**CITY OF LA VISTA  
MAYOR AND CITY COUNCIL REPORT  
DECEMBER 6, 2022 AGENDA**

<b>Subject:</b>	<b>Type:</b>	<b>Submitted By:</b>
APPLICATION FOR REPLAT – LOT 51A CENTECH BUSINESS PARK CENTECH BUSINESS PARK REPLAT SIX	◆ RESOLUTION ORDINANCE RECEIVE/FILE	CALE BRODERSEN ASSISTANT PLANNER

RE: Replat – Centech Business Park Replat 6 – Initial Review Letter

RE: Replat – Centech Business Park Replat 6 – Initial Review Letter Response

CITY OF LA VISTA  
PRELIMINARY PLAT

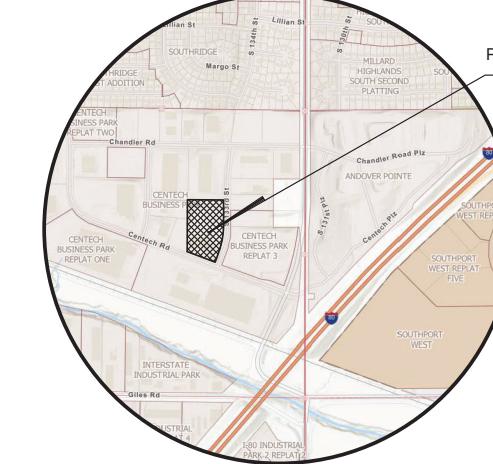
2. Per Section 3.03.02, please include the existing and proposed grades on the preliminary plat, with contours at intervals of five feet or less. If the proposed grades are not submitted by the subdivider, the purchaser/developer of said proposed Lot 1 shall submit them for approval prior to building permit issuance.

4. Per Section 3.03.07, please include on the preliminary plat the locations of all culverts, present structures and features, all utilities, and their sizes, as well as flow lines and elevations for existing sanitary and storm sewers consistent with this requirement.

**Invert elevations and rim elevations for both existing storm and sanitary sewer have been added to the preliminary plat.**
5. Per Section 3.03.10, please include on the preliminary plat the locations of all easements and all proposed improvements including sanitary sewers, water mains, stormwater drainage, and other improvements required.

6. Per Section 3.03.12, please include on the preliminary plat all easements for public utilities and rights of way, if applicable.  
**N/A.**
7. Per Section 3.03.14, please include on the preliminary plat the existing zoning classification, building setback lines, and proposed uses of land within the proposed subdivision.

**Existing grades have been added to the preliminary plat. The purchaser/developer of said proposed Lot 1 shall submit proposed grades prior to building permit issuance.**

**Utility easements and the proposed access easement have been added to the preliminary plat. There are no proposed improvements associated with this replat.**

**Zoning classification and building setbacks have been added to the preliminary plat. There is not proposed change to the use-type of the land.**
8. Per Section 3.03.16, please submit an erosion control plan consistent with this requirement. If this is not done by the subdivider, the purchaser/developer of said proposed Lot 1 shall submit an erosion control plan for approval prior to building permit issuance.

CITY OF LA VISTA  
FINAL PLAT

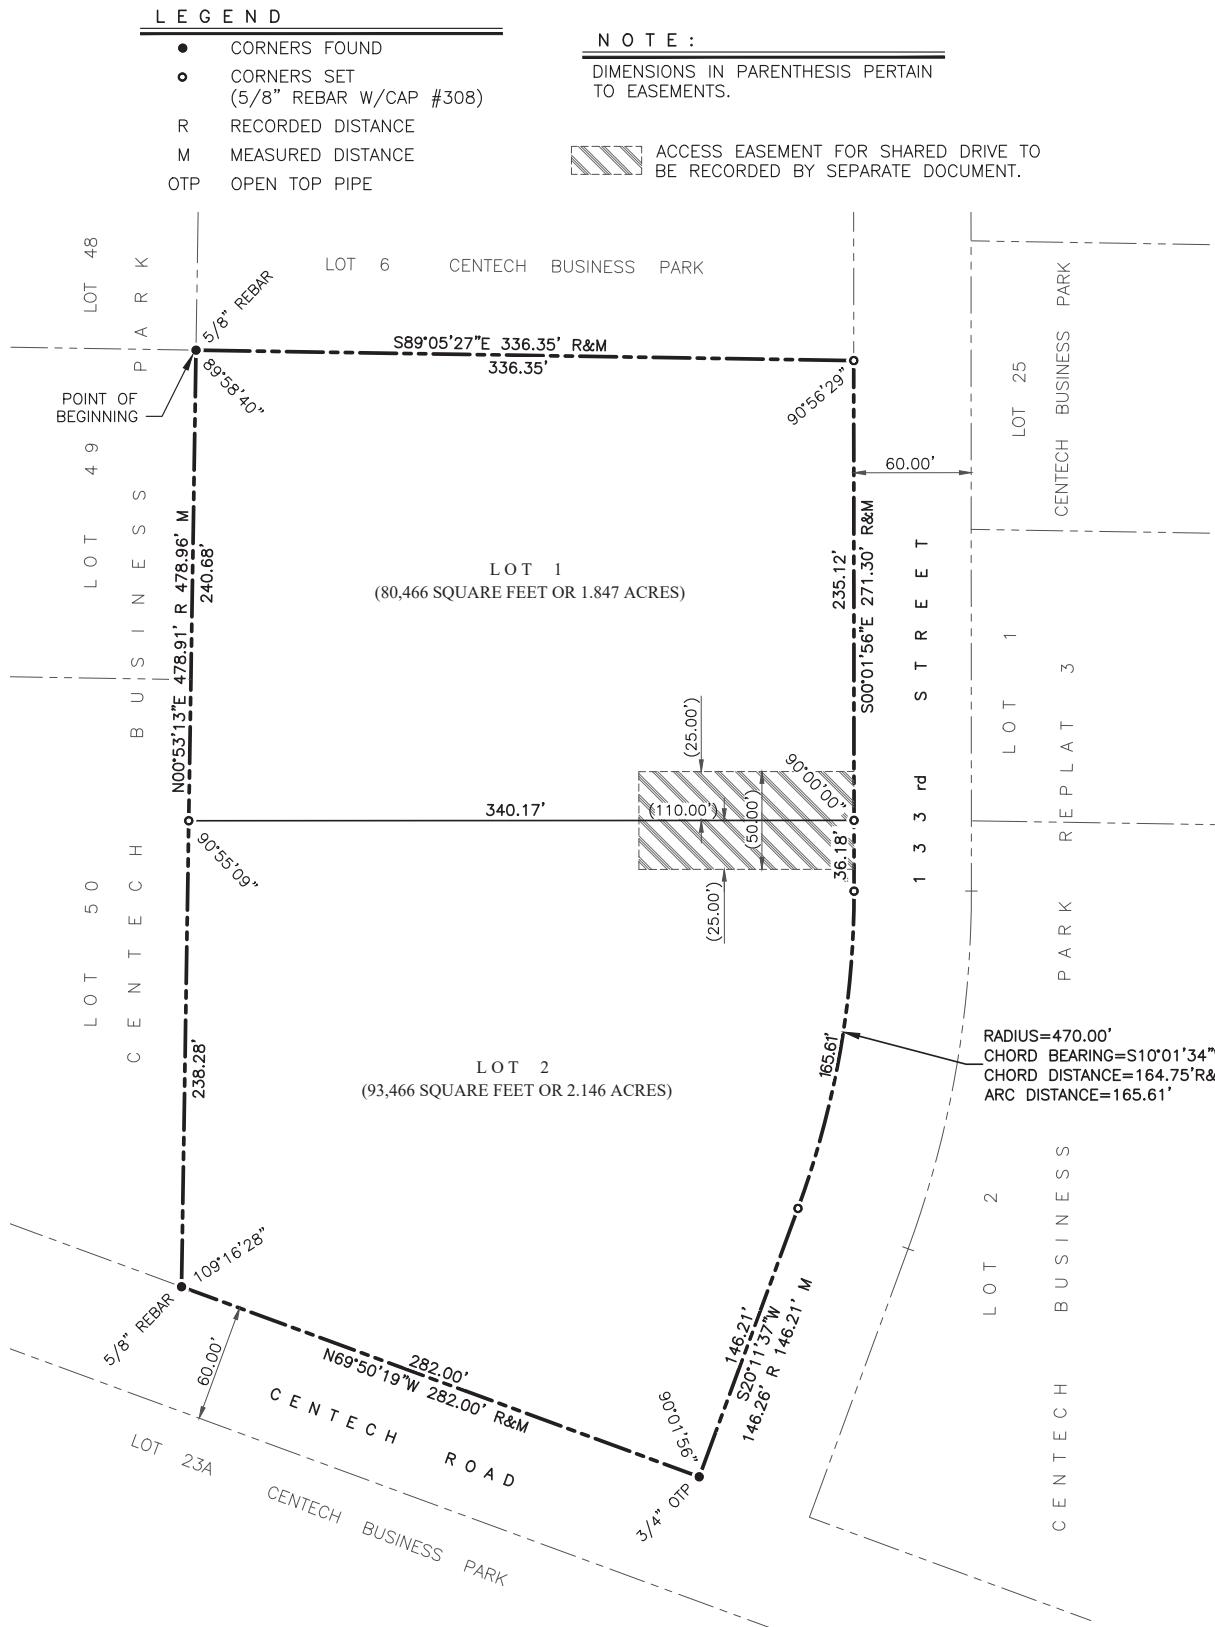
**N/A**
12. Per Section 3.05.13, please include a title block in the final plat for approval by the Planning Commission in form and content as per Section 10.03.

14. Please revise the City approval block (Section 10.04) and the Sarpy County Public Works approval block, as this is no longer an administrative plat.

18. Please find attached a redlined version of the plat from Sarpy County Public Works noting an error in the bearing on the west property line. Please ensure that the bearing and legal description match.

**Added to the final plat.**

**Updated on the final plat.**

**This has been updated on the final plat.**
